OJAI UNIFIED SCHOOL DISTRICT

BID ADDENDUM NO. 1 ISSUED 8/23/2019

REROOFING PROJECT AT SUMMIT ELEMENTARY PROJECT NO. 2019-1406

1 BLDGS. A & C ROOF DEMOLITION PLAN
1/8" = 1'-0"

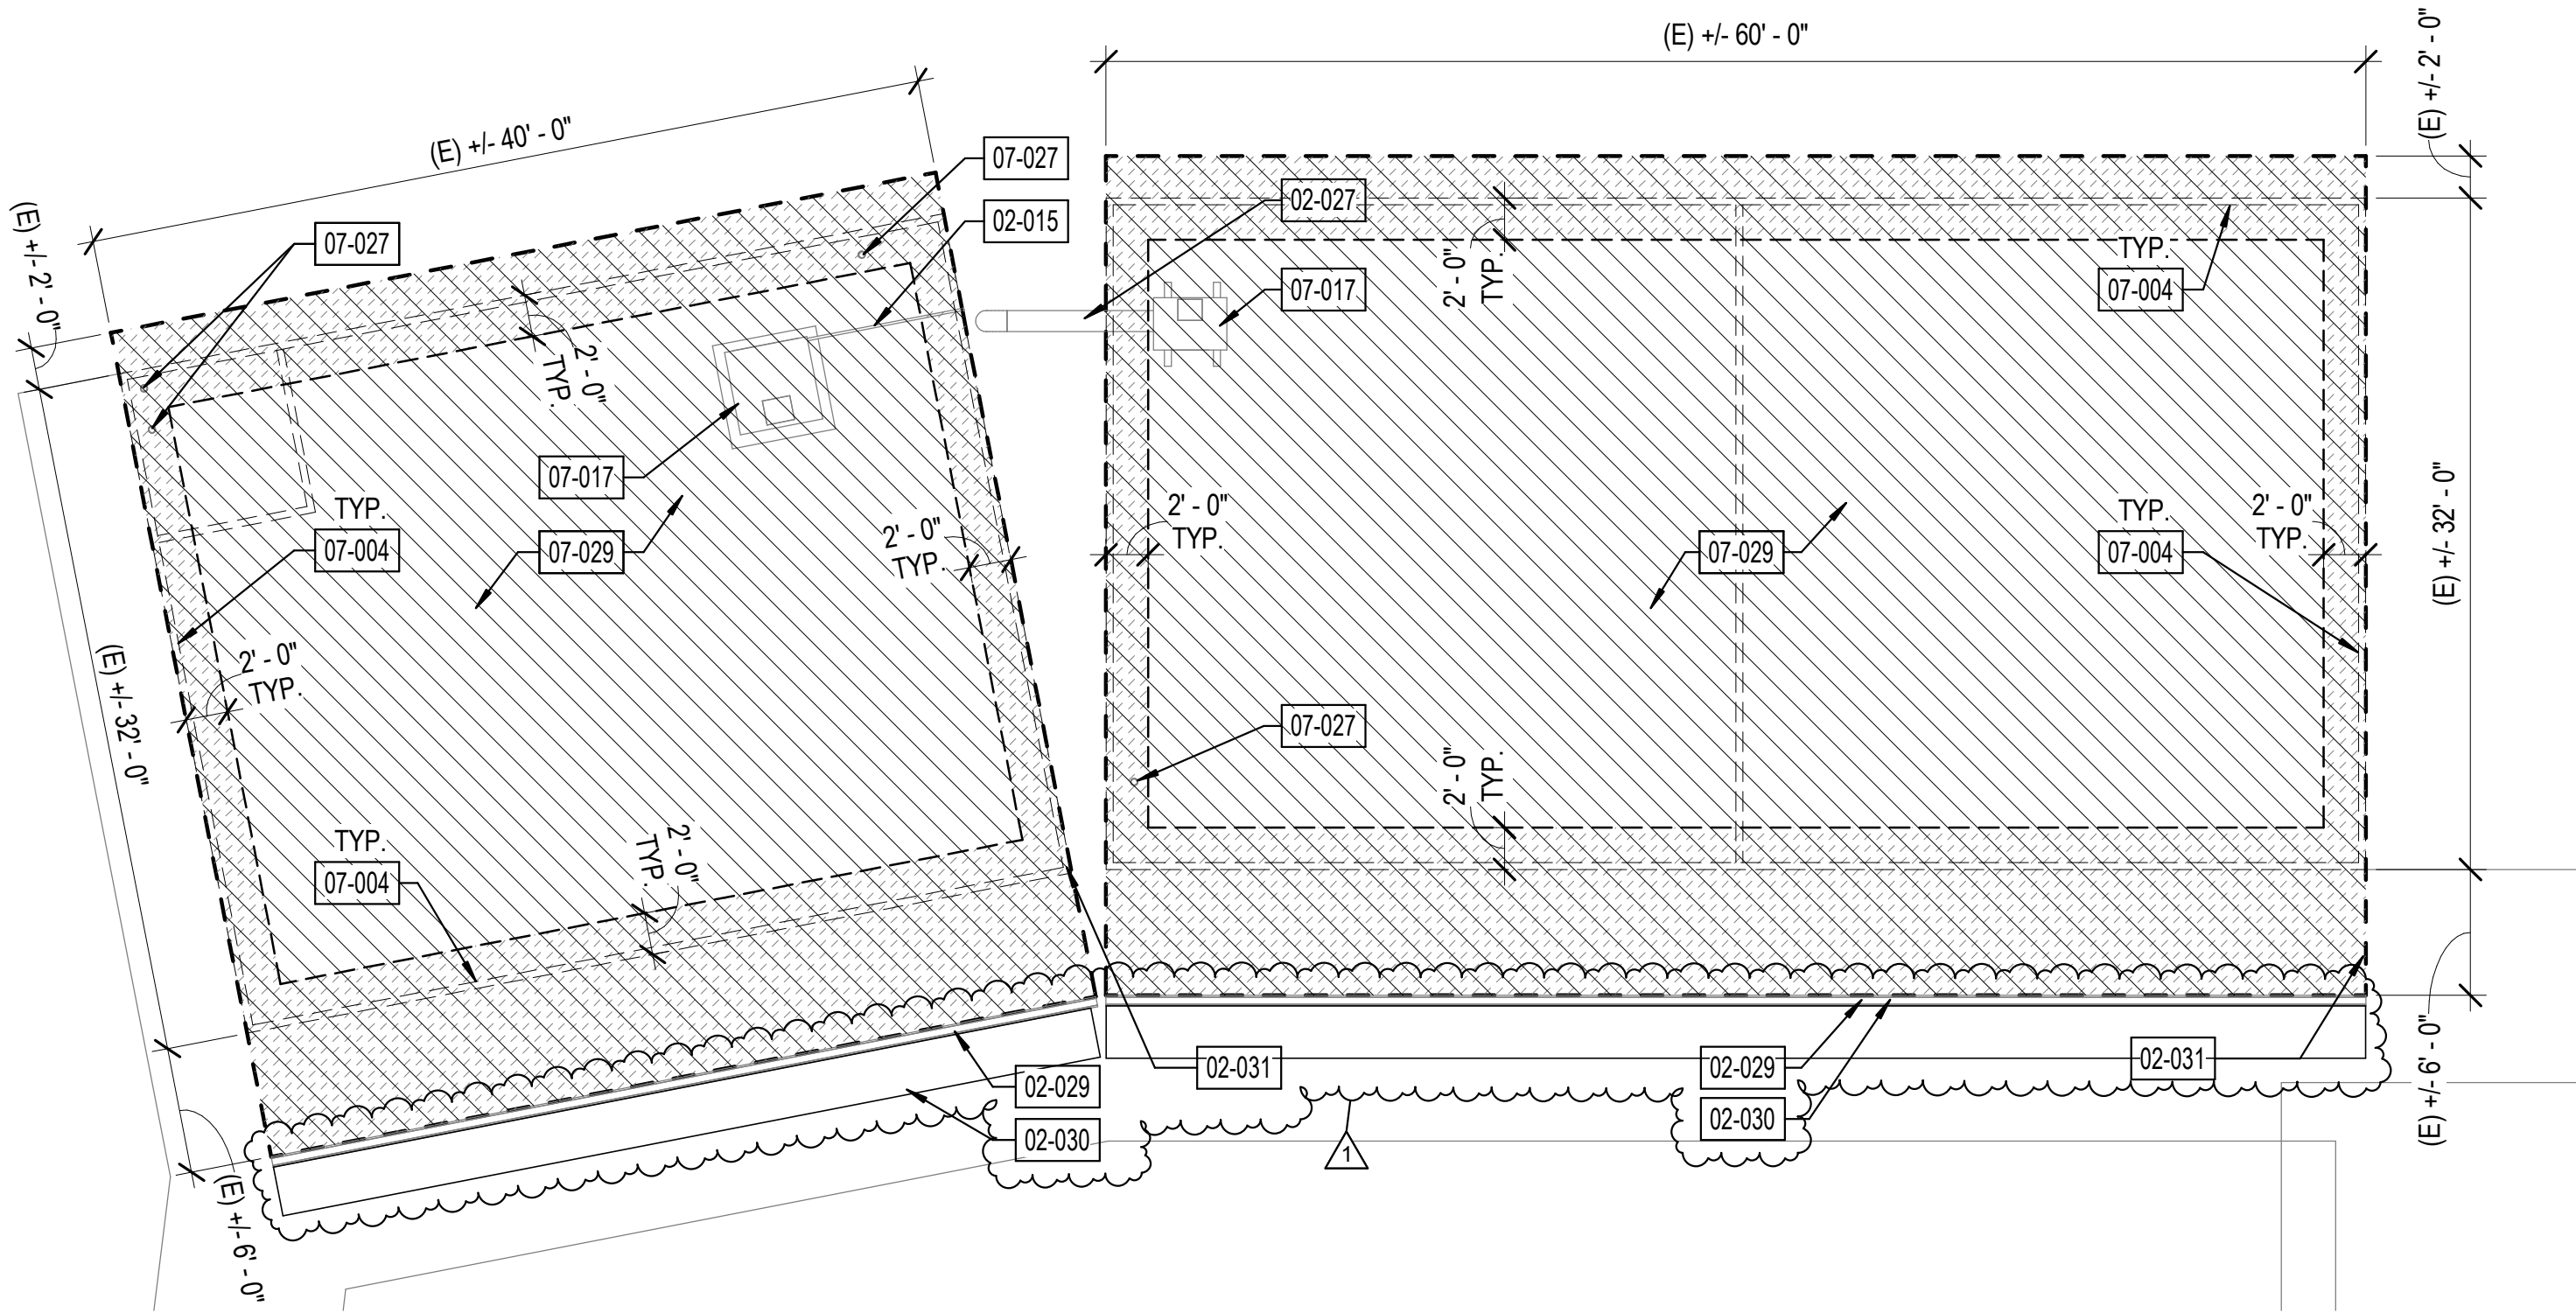
- Item 5. Drawings coordinated to show keeping the existing gutter in place and correct location of existing downspouts to be replaced.
D-1.0 revised. Refer to cloud and delta 1.
A-1.0 revised. Refer to cloud and delta 1.
- Item 6. Drawings revised to show existing metal shade.
D-1.0 revised. Refer to cloud and delta 1.
A-1.0 revised. Refer to cloud and delta 1.
- Item 7. AD-1.0 Details 7 and 15 revised to use mechanical fasteners for cover board and not for insulation board. Refer to cloud and delta 1.
